ADDENDUM NO. 3

PROJECT NAME: **JIM MATTOX PARK IMPROVEMENTS**

DATE: 9/2/2014

CIMS PROJECT NO.: **40-00362**

LC 1.0

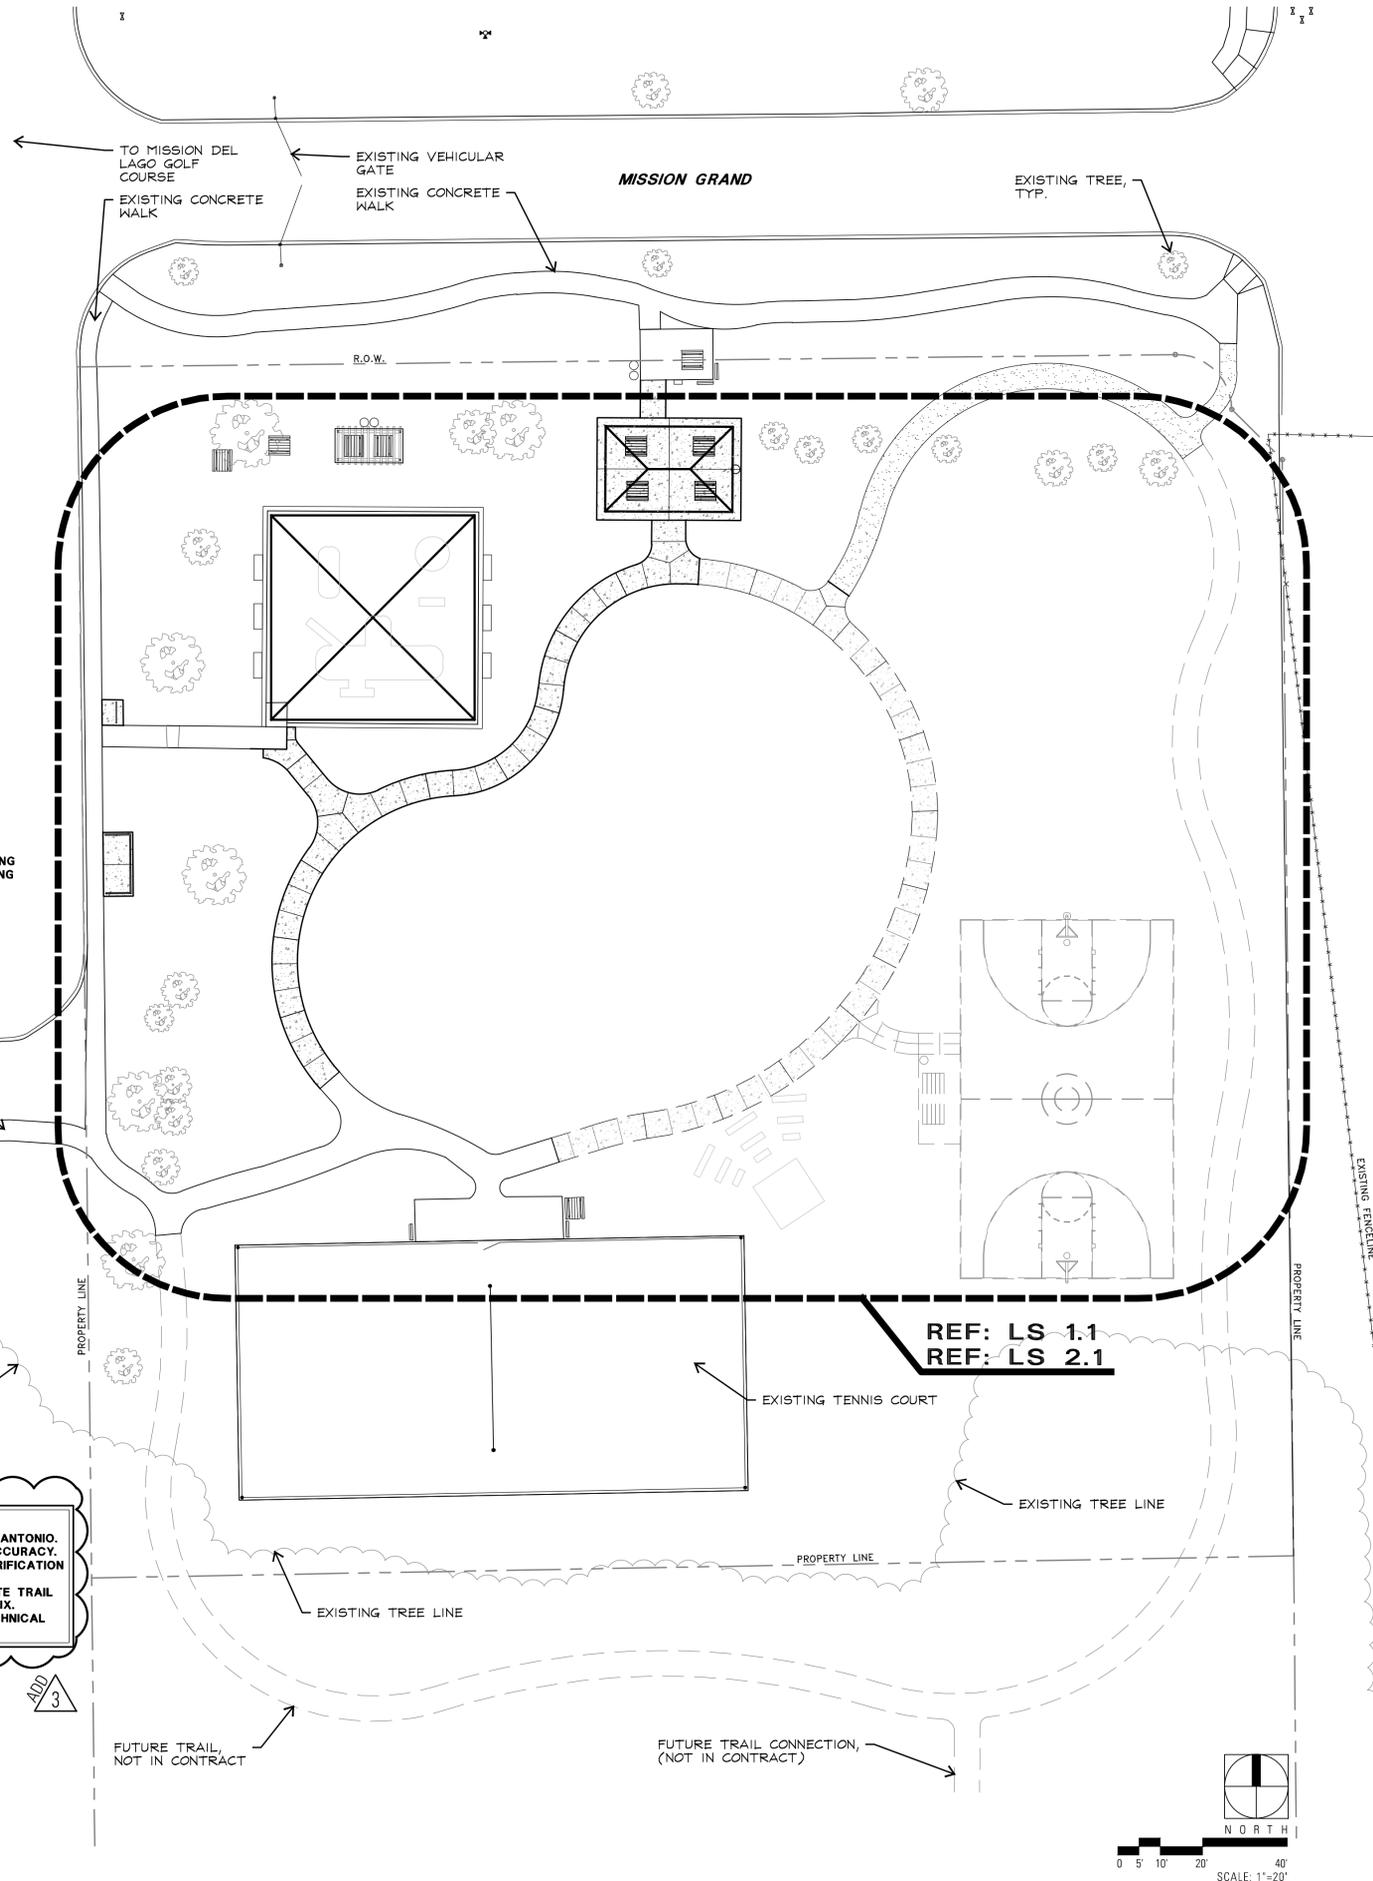
- Question #1 – On the Amenities table on drawing LC 1.1 Key A.1 states QTY 2 litter receptacles, however on drawing LS 1.1 we were only able to find 1 new trash receptacle to be installed. Please clarify how many litter receptacles are going to be needed?
Answer – One litter receptacle.
- Question #2 – Are there any detail drawings for the shade structure? Also what is the time restrictions for submitting for prior approval for the Pavilion and shade structures?
Answer – The material list on sheet LC1.1 identifies the shade structure and pavilion. Details are provided by the manufacturer. Contractor must submit details of structures from manufacturer prior to installation.

- LC 1.0 - Added note #16 – ‘Contractor is responsible for the SWPPP plan and all required BMP’s’.
- LC 1.1- Updated Remarks to port-o-potty enclosure, concrete park tables, and pavilion. Added new notes #1 and #2.
- LS 1.1 – Added existing spot grades and added notes #6 and #7.
- Added Item #12 to Bid Form – SWPPP plan and BMP’s. Replace and utilize revised Form 025 Unit Pricing uploaded to the City’s website.

KEY	DESCRIPTION /MODEL NUMBER	COLOR	FINISH	CONTACT	REMARKS
M.1	CONCRETE MIX FOR WALK-FLYASH -160 LBS/YD 3/4" LIMESTONE -1030 LBS/YD RIVER SAND- 1414 LBS/YARD CEMENT- 240 LBS/YARD	N/A	MEDIUM BROOM FINISH	N/A	• REFERENCE TECHNICAL SPECIFICATIONS FOR SUBMITTAL AND MOCK-UP REQUIREMENTS.
M.2	ADD ALTERNATE #1B DECOMPOSED GRANITE	BROWN	N/A	KELLER MATERIALS PHONE: 210-390-0953 OR APPROVED SUBSTITUTE	• REFERENCE TECHNICAL SPECIFICATIONS FOR SUBMITTAL AND MOCK-UP REQUIREMENTS. • INSTALL MATERIAL AS NEEDED TO ENSURE NO GAPS ARE VISIBLE
A.1	LITTER RECEPTACLE STEEL/SITES SERIES MODEL # NSDC-36 QTY (2)	BLACK	POWDER COAT	VICTOR STANLEY 1.800.368.2573	SURFACE MOUNT; SUBMIT ANCHOR DETAILS FOR APPROVAL BY LANDSCAPE ARCHITECT PRIOR TO INSTALLATION.
A.2	SHADE STRUCTURE 'SUPERSPAN' EMBED MOUNT 48"x48"x14' ENTRY HEIGHT, 4 POST	CANOPY: YELLOW POSTS: BLUE	POWDER COAT	WHITNEY MARKET SUN PORTS PHONE: 512-836-5500	• SUBMIT PRODUCT DATA FOR LANDSCAPE ARCHITECT'S APPROVAL PRIOR TO INSTALLATION. PRODUCT DATA TO INCLUDE STRUCTURAL FOOTING DESIGN BY MANUFACTURER. • CONTRACTOR TO PROVIDE SEALED AND STAMPED STRUCTURAL DRAWINGS (PROVIDED BY MANUFACTURER) PRIOR TO INSTALLATION. • INSTALL PER MANUFACTURER'S SPECIFICATIONS.

A.3	PORT-O-POTTY ENCLOSURE REUSE ENCLOSURE FROM LAKESIDE PARK	EXISTING	N/A	CoSA PARKS DEPARTMENT JAMAAL MORENO PHONE: 210-207-6924	• CONTRACTOR TO COORDINATE WITH CoSA PARKS DEPARTMENT FOR RE-USE OF EXISTING ENCLOSURE FROM LAKESIDE PARK. • CONTRACTOR TO PROVIDE STRUCTURAL FOOTING DESIGN FROM MANUFACTURER. • CONTRACTOR TO PROVIDE SEALED AND STAMPED STRUCTURAL DRAWINGS (PROVIDED BY MANUFACTURER) PRIOR TO INSTALLATION.
A.4	ADD ALTERNATE #3 CONCRETE PARK TABLE 3' x 6'-7" NUMBER 10 ADA WITH (2) 6"x18" BENCHES. SMOOTH TOP WITH ROUND EDGES. (4 TOTAL)	STANDARD	STANDARD	MACON CONCRETE	• SUBMIT PRODUCT DATA FOR LANDSCAPE ARCHITECT'S APPROVAL PRIOR TO INSTALLATION. • INSTALL PER MANUFACTURER'S SPECIFICATIONS, • OR APPROVED SUBSTITUTE.
A.5	PAVILION 20' X 30' MODEL: DENVER	ROOF: TAN POSTS: RED	STANDARD	CLASSIC RECREATION SYSTEMS PHONE: 926-775-3307	• CONTRACTOR TO SUBMIT SHOP DRAWINGS FOR LANDSCAPE ARCHITECT'S APPROVAL. SHOP DRAWINGS TO INCLUDE STRUCTURAL FOOTING DESIGN BY MANUFACTURER. • INSTALL PER MANUFACTURER'S RECOMMENDATIONS. • CONTRACTOR TO PROVIDE SEALED AND STAMPED STRUCTURAL DRAWINGS (PROVIDED BY MANUFACTURER) PRIOR TO INSTALLATION.

NOTES:
1. BASE INFORMATION PROVIDED BY THE CITY OF SAN ANTONIO. TBG PARTNERS CANNOT ATTEST NOR VERIFY THE ACCURACY. CONTRACTOR SHALL BE RESPONSIBLE FOR FIELD VERIFICATION PRIOR TO CONSTRUCTION.
2. ALL DISTURBED AREAS INCLUDING EDGE OF CONCRETE TRAIL TO BE RE-SEED WITH BERMUDA AND RYE GRASS MIX. REFER TO NATIVE SEED MIX SECTION 32 9219 IN TECHNICAL SPECIFICATIONS.
